Solace of Colorado Springs (Lot 1) – Deviation Requests

- Paonia Street
- Galley Road Striping

**DEVIATION REQUEST
 AND DECISION FORM**

SOLACE APARTMENTS

DEVIATION EXHIBIT
SOLACE APARTMENTS
JOB NO. 25174.00
5/1/20
SHEET 1 OF 1

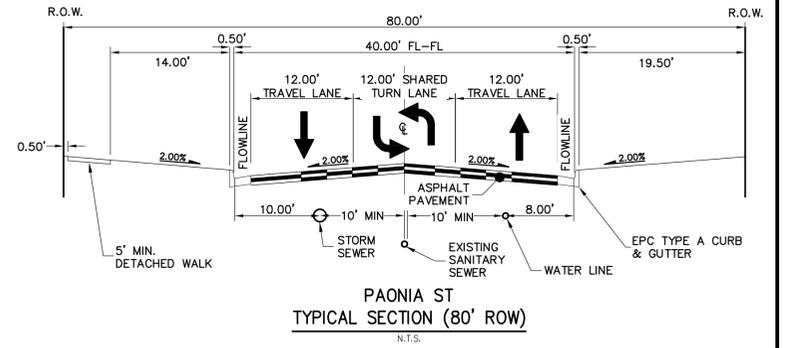
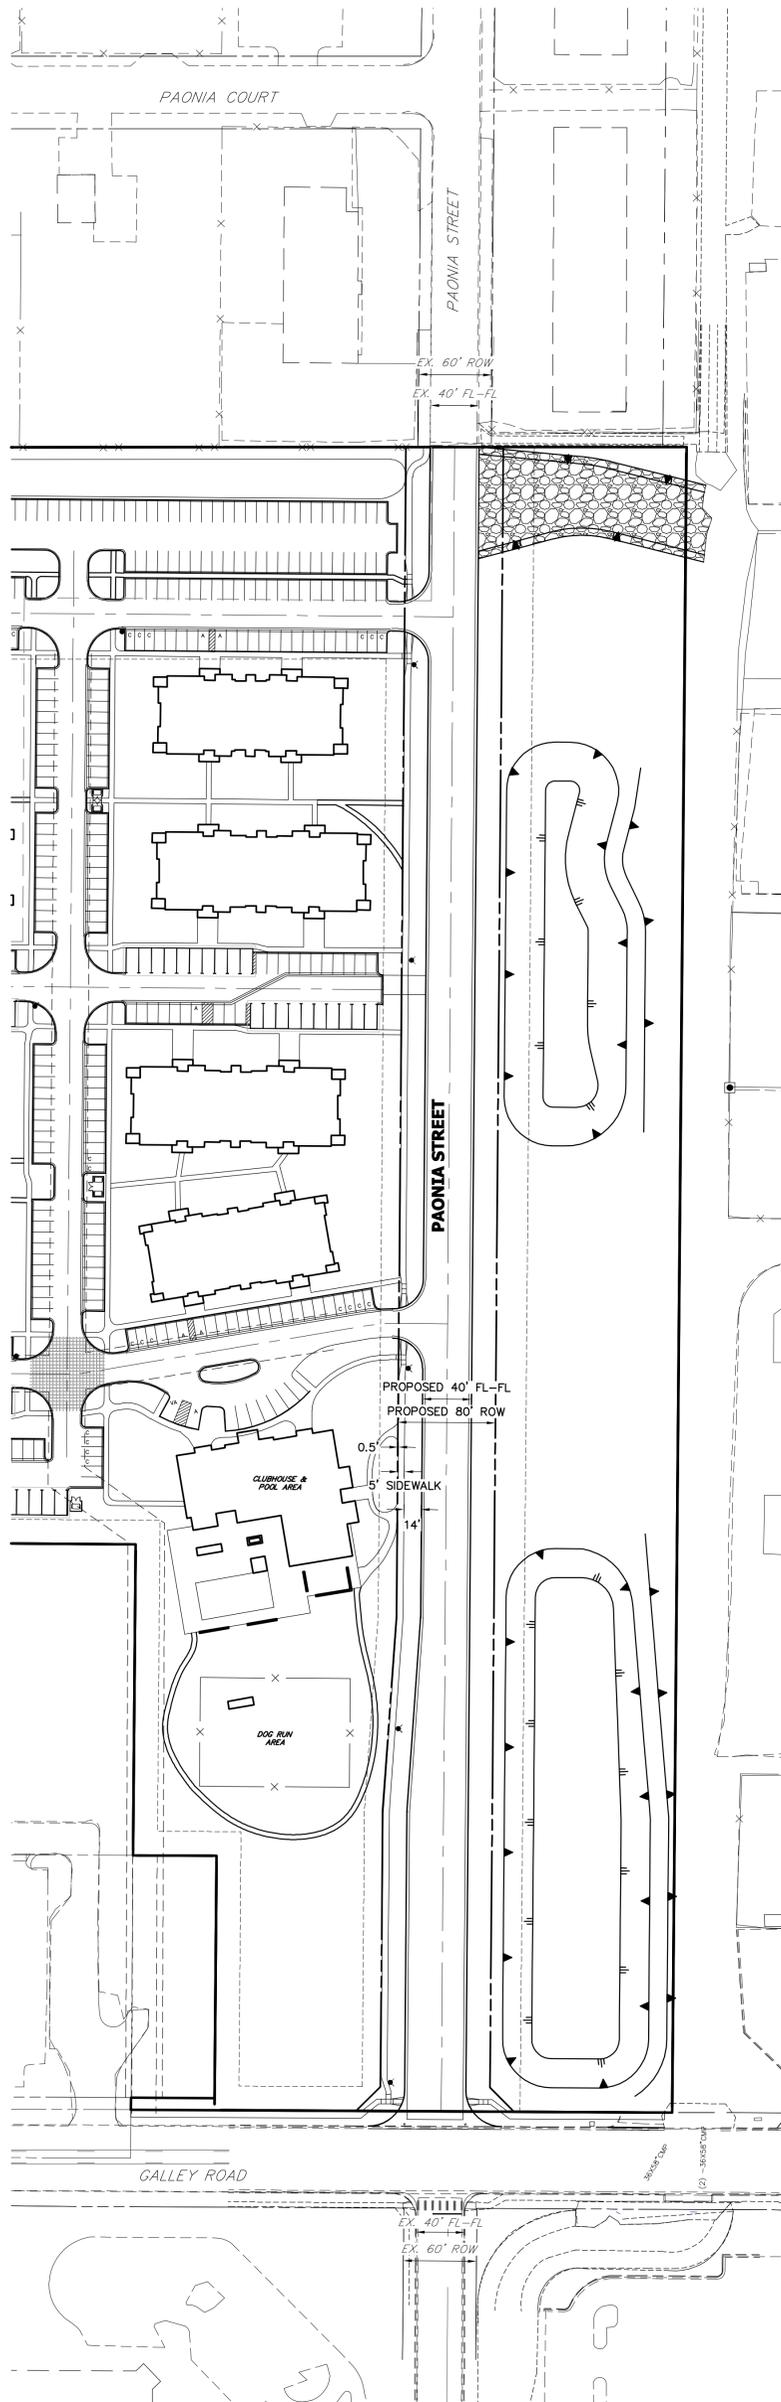
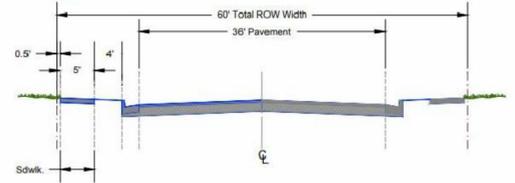
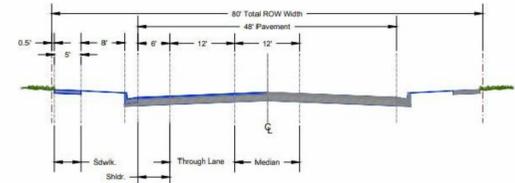
A deviation from the standards of or in Section **2.2.4.B.4 for Roadway Cross Sections** of the Engineering Criteria Manual (ECM) is requested.

An ECM criterion for an 80' ROW width (Urban Non-Residential Collector) typical section includes 48' of pavement (lip-lip) typical, typical curb and gutter, and 8' tree lawns with a 5' detached sidewalk on the west side.

The reason for the requested deviation of an alternate road section is that Paonia Street to the north and south of the development exists as a 60' ROW with 36' (lip-lip) pavement area. The proposed design is to maintain a consistent section through the Solace development and the entire Paonia corridor while still providing the requested 80' ROW of an Urban Non-Residential Collector. The walk is proposed on the west side to continue pedestrian movement from south to north through the corridor. No walks currently exist on the east side of the road, north or south of this development. Furthermore, there is currently no space for a walk to be considered in those existing developments due to the existing infrastructure. This removes the likelihood of any potential future connectivity for a walk on the east side of Paonia through this corridor. Although no walk is proposed, the horizontal space for a walk is still being dedicated should future redevelopment of this corridor warrant additional connectivity.

The proposed alternative is for Paonia Street to have an 80' ROW but the same road section as the "Typical Urban Residential Collector Cross Section" listed in Chapter 2, section 2.2.4.B.5 of the ECM. The only difference will be a 14' tree lawn instead of an 8' tree lawn due to the extra ROW width.

The ECM standard is inapplicable to the particular situation due to the fact that existing Paonia Street to the north and south of the development have 60' ROW with road section "Typical Urban Residential Collector Cross Section" listed in Chapter 2, section 2.2.4.B.5 of the ECM. This development would generate an estimated 2, 547 vehicle-trips during the day. This falls within the criteria specified in Table 2-7 specifying a design ADT <10,000.

This deviation will produce a development that interconnects with existing Paonia Street's typical corridor to the north and south. The standard section would unnecessarily interrupt the continuity along Paonia Street.

The deviation will not adversely affect safety or operations. Pedestrians will be further away from the traveled way with a larger tree lawn. Intersection crossings will have a reduced length meaning pedestrians will be in possible vehicle paths for less time, reducing risk of accidents.

Maintenance of the roadways will be positively impacted. The smaller roadway section, with less pavement mean long term pavement repair and maintenance cost savings. Similarly, the walkway not constructed on the east side of the road will reduce concrete repair and replacement costs. Long term intersection signalization costs will be reduced due to smaller poles & mast arms.

Yes, the deviation meets the design intent and purpose of the ECM standards. There will not be an appreciable increase in the amount of traffic on Paonia Street to necessitate the cross section for this segment of Paonia Street.

Yes, the deviation meets the control measure requirements of Part I.E.3 and Part I.E.4 of the County's MS4 permit. The runoff generated by a smaller section will be reduced due to less pavement. A majority of all runoff created by these improvements will be captured in public curb inlets and piped to an adjacent private detention and water quality pond. The runoff will be treated and detained to historic conditions before being released back into the Center Tributary of Sand Creek.

LEFT TURN LANE DEVIATION
 SOLACE APARTMENTS
 JOB NO. 25174.00
 7/14/20
 SHEET 1 OF 1

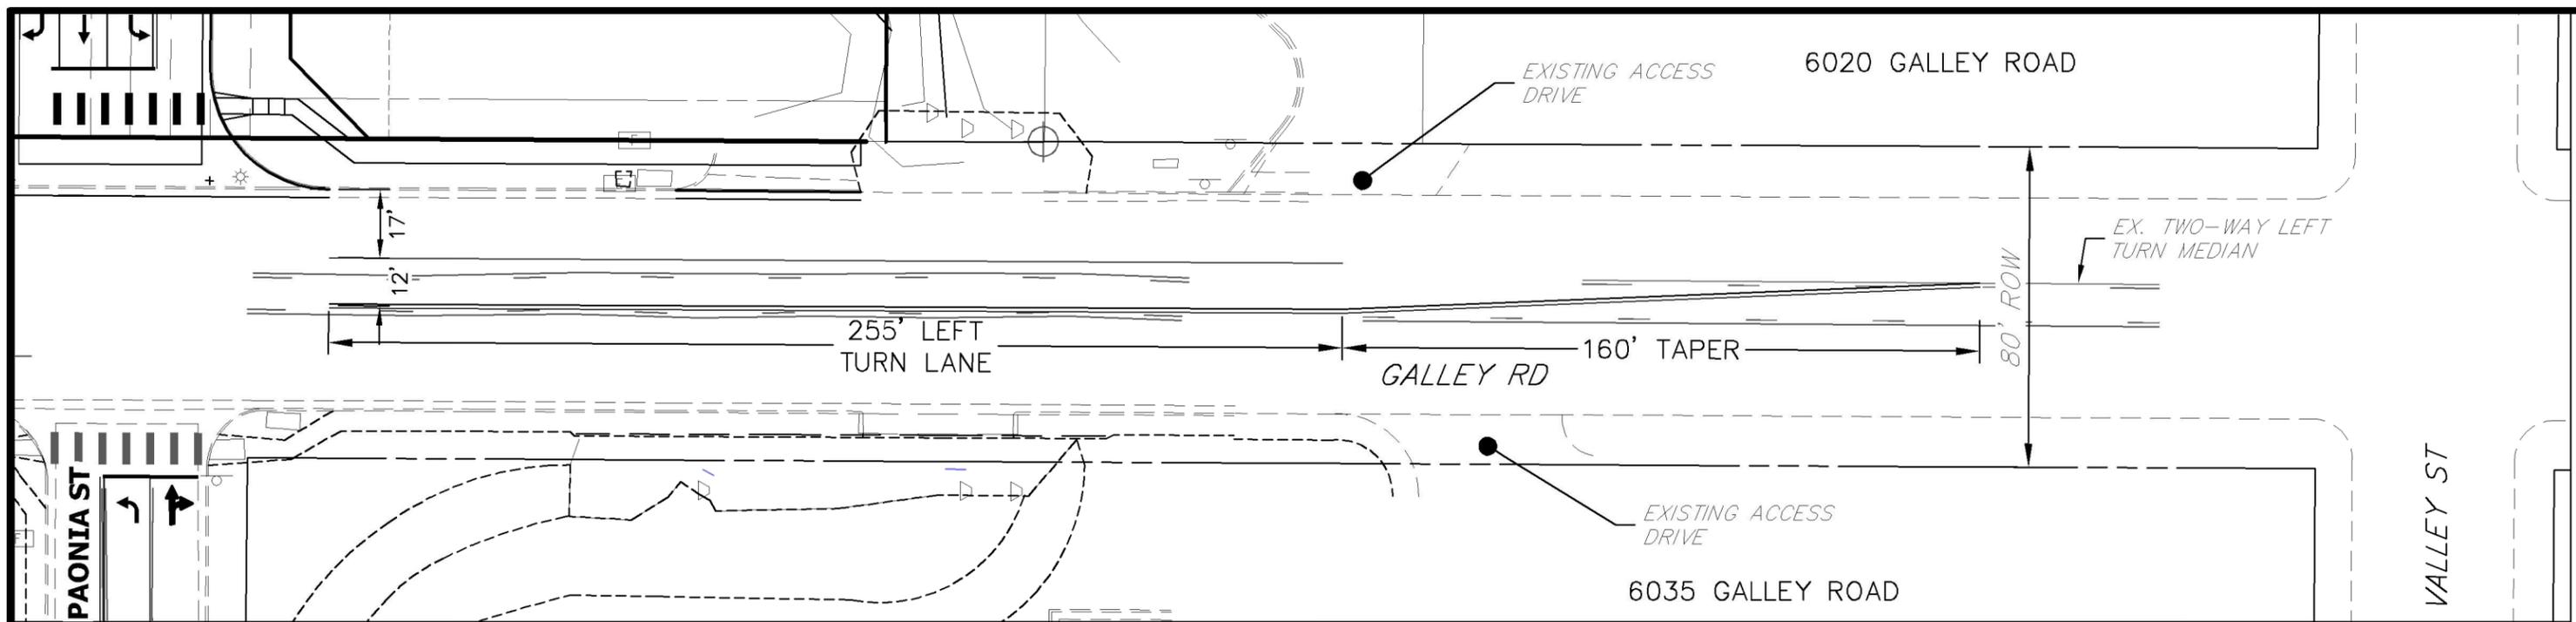
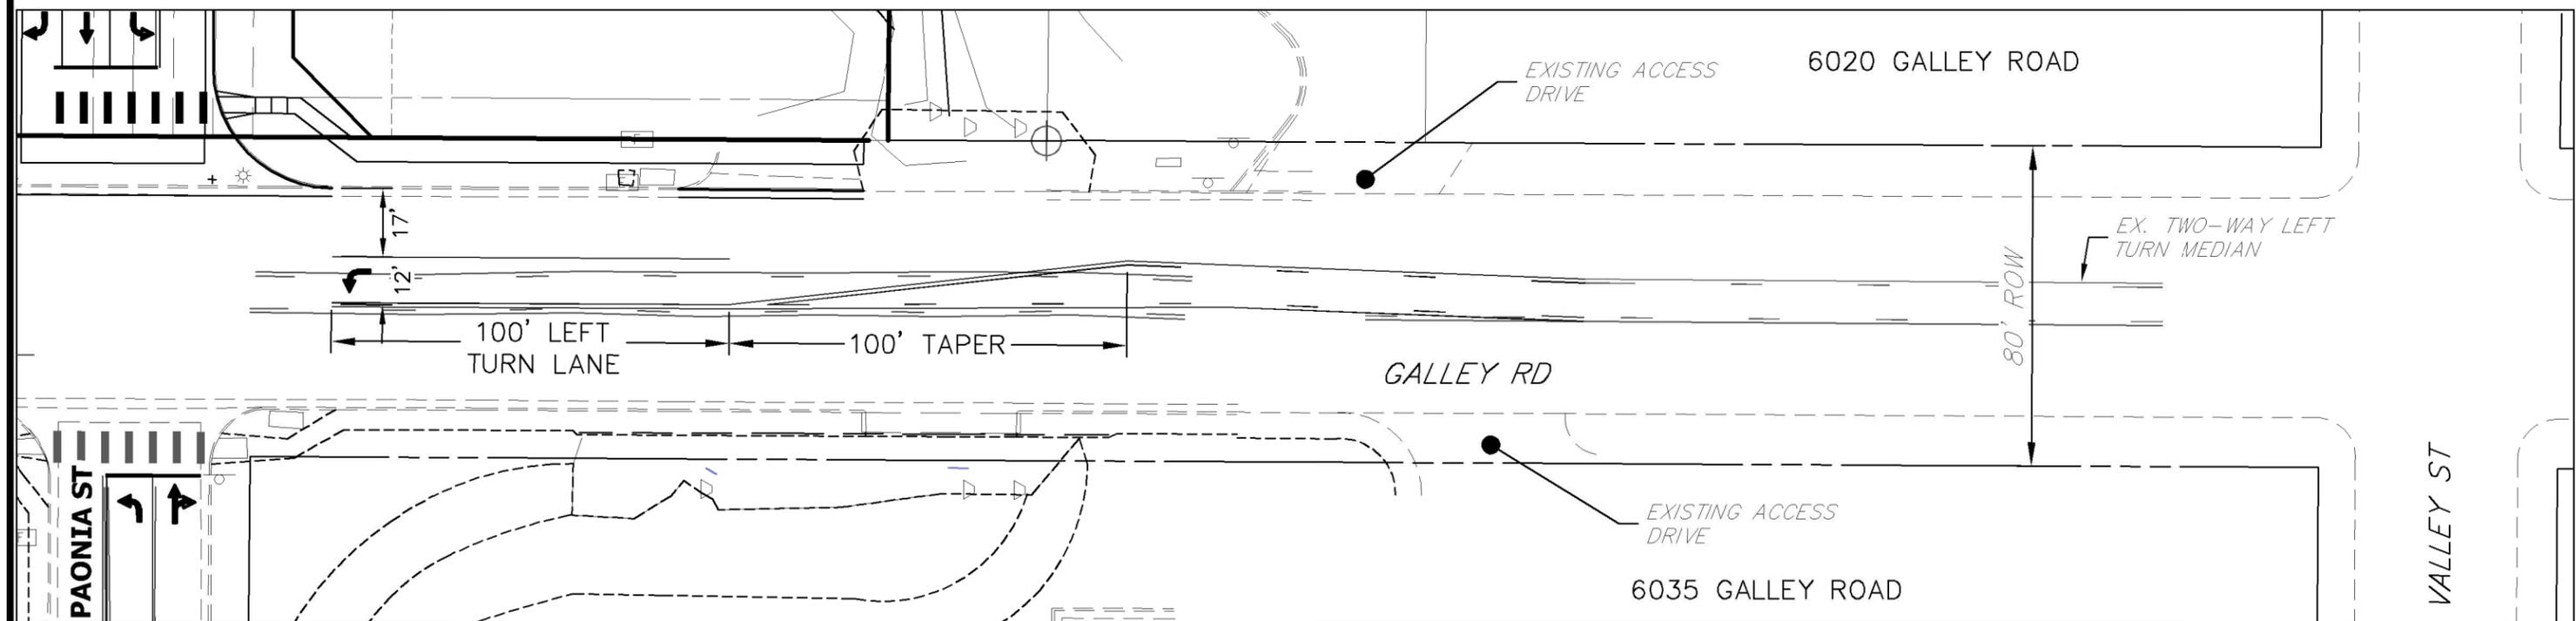
A deviation from the standards of or in Section **2.3.7.E for Turn Lane Design** of the Engineering Criteria Manual (ECM) is requested.

Required deceleration and taper length ECM criteria for a 155' lane length and a 160' taper from Table 2-26 for a 40 MPH design speed.

The reason for the requested deviation of a smaller left turn lane is to prevent restricting turn movements in and out of the surrounding businesses along Galley Road. Accesses for an existing parcel located at 6020 Galley Road and a parcel located at 6035 Galley Road would be directly impacted by the proposed turn lane. The deviation for the proposed design will provide adequate capacity for westbound traffic turning left onto Paonia Street while still providing full movement access to the businesses on the north and south side of galley Road. Per ECM criteria section 2.3.7.E.2 on page 2-53, the taper shall also meet the minimum 8:1 ratio. This removes the likelihood of any potential traffic conflicts through this corridor.

The proposed alternative is for the westbound left turn lane located on Galley Road at the intersection of Paonia Street to have a 100' left turn lane and a 100' taper for a total length of 200'. Typical turn lanes, per Chapter 2, Section 2.3.7.E of the ECM for a 40 MPH design speed, require a total length of 415'. Thus, the proposed alternative is 215' shorter than the standard.

The ECM standard is inapplicable to the particular situation due to the fact that existing developments to the north and south of Galley Road have access drives that would be impaired by the addition of a 415' left turn lane and this development should not restrict existing parcel access. The proposed shortened left turn lane would still supply adequate volume for westbound traffic turning left onto Paonia Street, while still allowing the existing access drives to the businesses along Galley Road to retain their full movement.

This deviation will prevent any negative impacts to the surrounding properties. A 415' left turn lane would block the accesses to existing businesses on both the north and south side of Galley Road. By shortening the left turn lane's deceleration lengths, any negative impacts to the existing businesses will be resolved while also removing conflict points at these access locations that will improve public safety.

The deviation will not adversely affect safety or operations. The existing roadway does not have a protected left turn lane at the intersection of Galley Road and Paonia Street. The proposed deviation will improve on the existing condition by adding a protected left turn lane, while still allowing the existing businesses along Galley Road to have full movement accesses. The shorter left turn lane will remove conflict points at these access locations reducing the chances of a collision.

Maintenance of the roadways will be not be adversely impacted. The pavement section of the existing Galley Road will remain unchanged. Only striping shall be utilized to make the proposed changes at the intersection of Galley Road and Paonia Street.

Yes, the deviation meets the design intent and purpose of the ECM standards. There will not be an appreciable increase in the amount of traffic on Galley Road to necessitate the full left turn lane section. Per page 2-53, the taper shall meet the minimum 8:1 ratio. The existing access locations along Galley Road shall also not be impacted by the addition of the shortened left turn lane. They shall retain their full movement capabilities in order to prevent any adverse impacts to the local businesses.
